# HISTORIC AND DESIGN REVIEW COMMISSION

December 20, 2023

**HDRC CASE NO:** 2023-473  
**ADDRESS:** 110 E HOUSTON ST  
106 E HOUSTON ST  
114 E HOUSTON ST  
143 N MAIN ST  
**LEGAL DESCRIPTION:** NCB 909 (RAND GARAGE), LOT 20  
**ZONING:** D, H, RIO-3  
**CITY COUNCIL DIST.:** 1  
**DISTRICT:** Main/Military Plaza Historic District  
**APPLICANT:** Jennifer Gribble/INSITE  
**OWNER:** RAND BUILDING LTD  
**TYPE OF WORK:** Fenestration modifications, ADA ramp installation, privacy screen installation, installation of patio seating and sidewalk modifications  
**APPLICATION RECEIVED:** November 21, 2023  
**60-DAY REVIEW:** January 20, 2024  
**CASE MANAGER:** Edward Hall

2 FLOOR PLAN: PROPOSED  
SCALE: 1/8" = 1'-0"

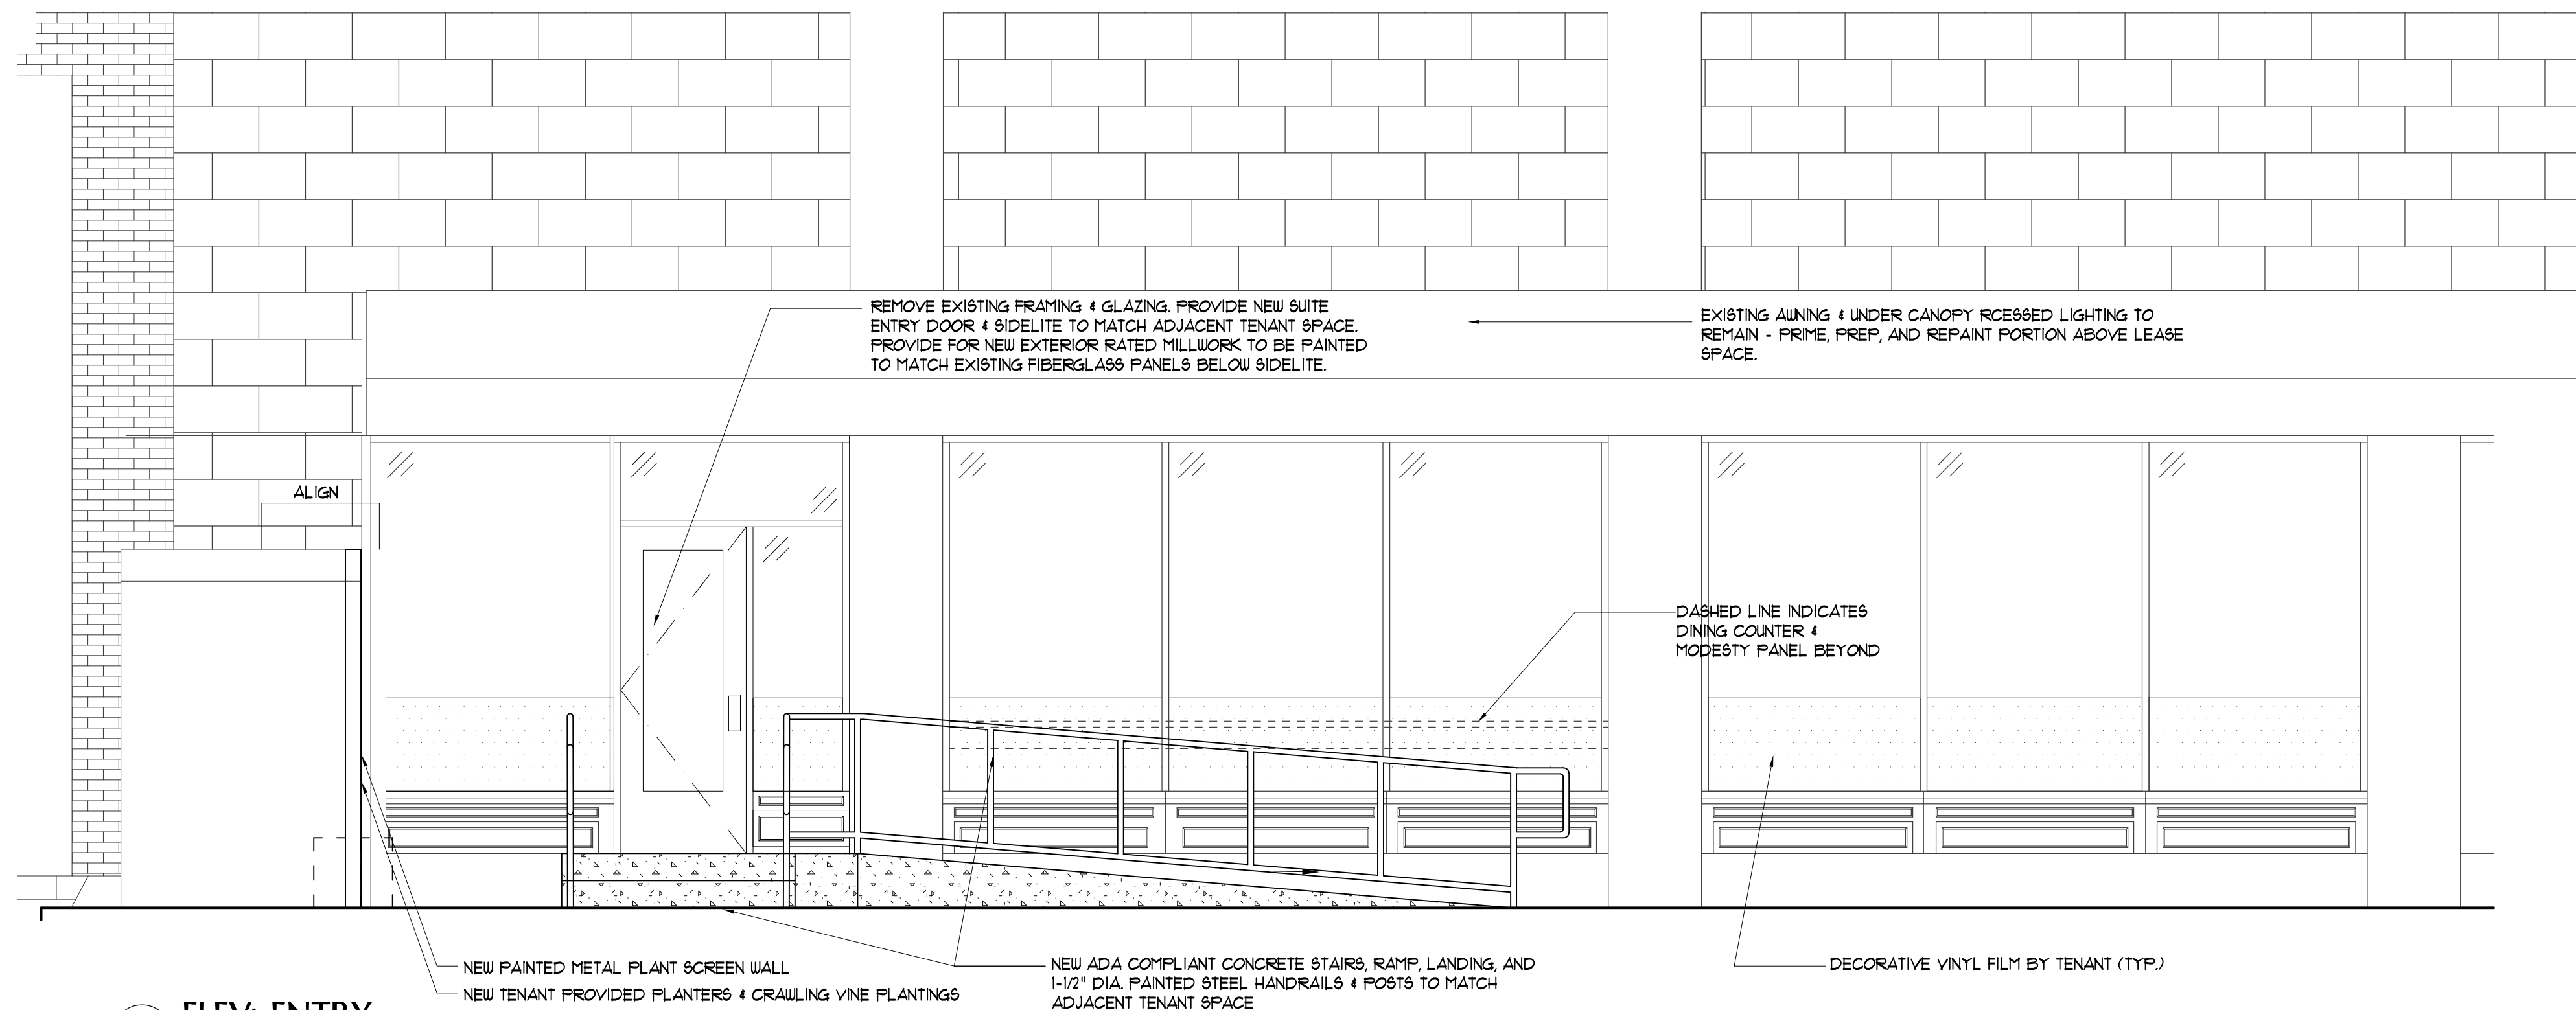
- b. STOREFRONT SYSTEM MODIFICATION – The applicant has proposed to modify the existing storefront system by removing a section and installing a pedestrian door on the Soledad façade. The applicant has proposed for the pedestrian door to match a previously installed pedestrian door on this facade. The applicant has proposed to match the profile of the existing storefront's system's low wall. Generally, staff finds the proposed modifications to be appropriate; however, staff finds that the proposed new pedestrian door should be wood.

- c. RAMP, STAIR & LANDING – The applicant has proposed to install an ADA complaint set of stairs, ramp and landing on the sidewalk adjacent to the proposed pedestrian door. The applicant has noted that these elements are to match those previously installed at an adjacent tenant space, including railings. Staff finds the proposed scope of work to be appropriate.

- 1. Staff recommends approval of item #1, the modification to the existing storefront system based on finding b with the following stipulation:
  - i. That the proposed new pedestrian door be wood.

- 2. Staff recommends approval of item #2, the installation of a ramp, stair, and landing based on finding c, as submitted.
- 3. Staff recommends approval of item #3, the installation of vinyl window film based on finding d with the following stipulation:

4 ELEV: PRIVACY SCREEN  
SCALE: 3/8" = 1'-0"

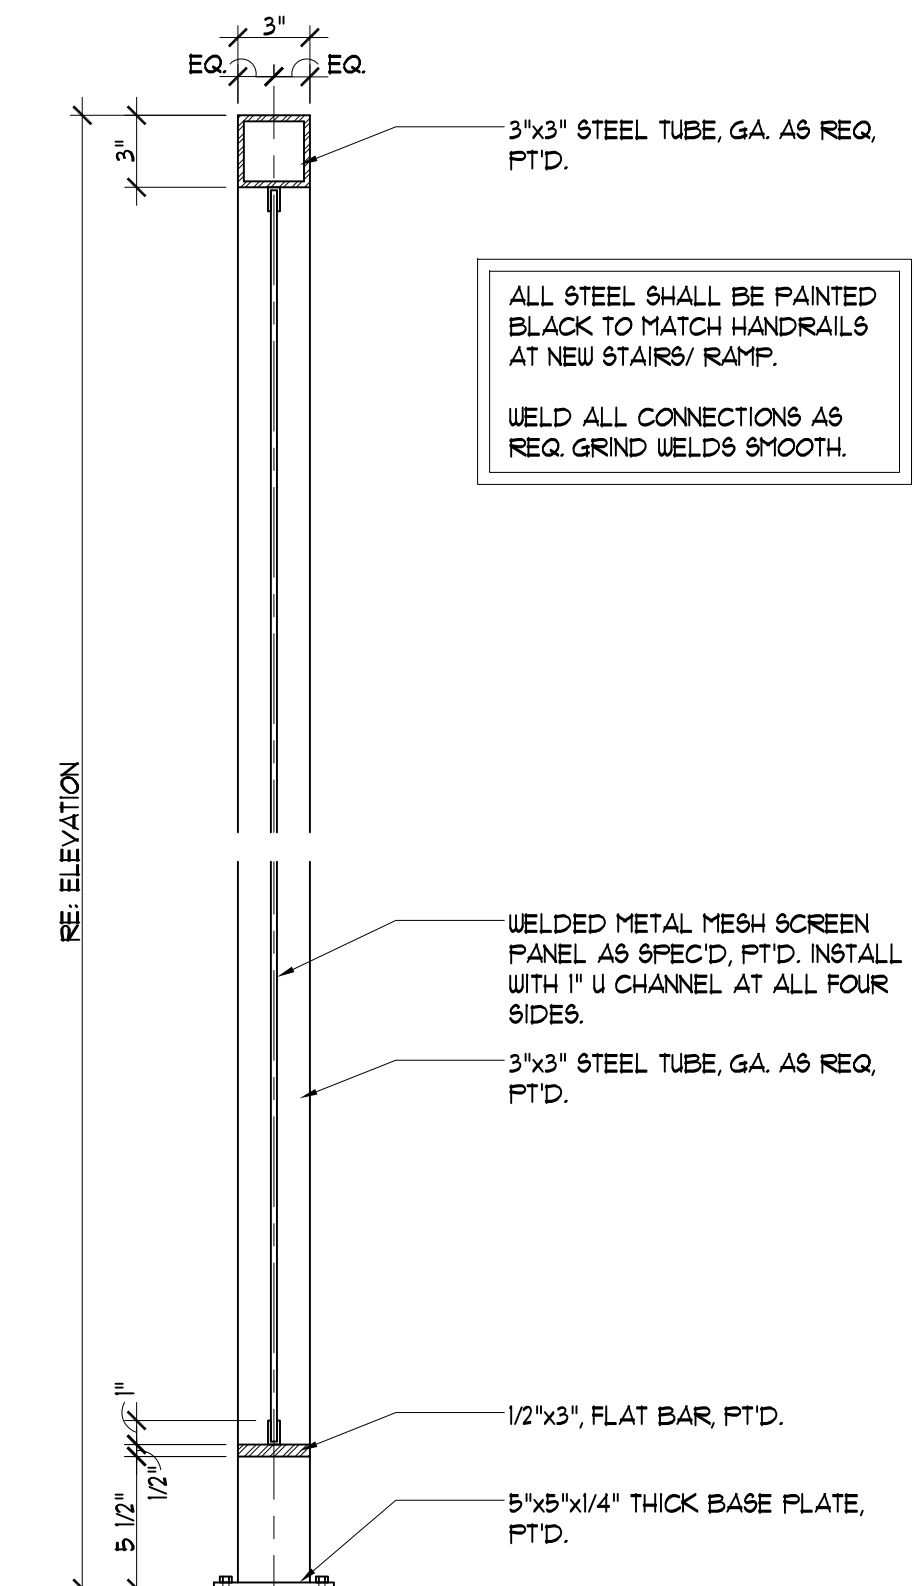
- e. PATIO SEATING – Along Soledad Street, the applicant has proposed to install patio seating within the right of way to feature chairs, tables, planters and a screening wall to screen the proposed patio from vehicular traffic entering the parking structure to the immediate south. Generally, staff finds the proposed patio installation to be appropriate; however, staff finds that six (6) feet of clearance should be maintained between the proposed seating area and the back of curb to provide adequate pedestrian and ADA access. Additionally, Staff finds that all patio furniture, including tables, chairs, umbrellas and planters are to be submitted to OHP staff for review and approval. All patio furniture, per the UDC Section 35-674(i)(2) should be constructed of wood, metal, stone, terra cotta, cast stone, hand-sculpted concrete or solid surface materials. Plastic is not allowed. The applicant is responsible for complying with this section of the UDC.

- 4. Staff recommends approval of item #4, the installation of patio seating based on findings e and f with the following stipulations:
  - i. That at least six (6) feet of clearance be maintained at all times between the patio furniture/planters and the back of the sidewalk curb.
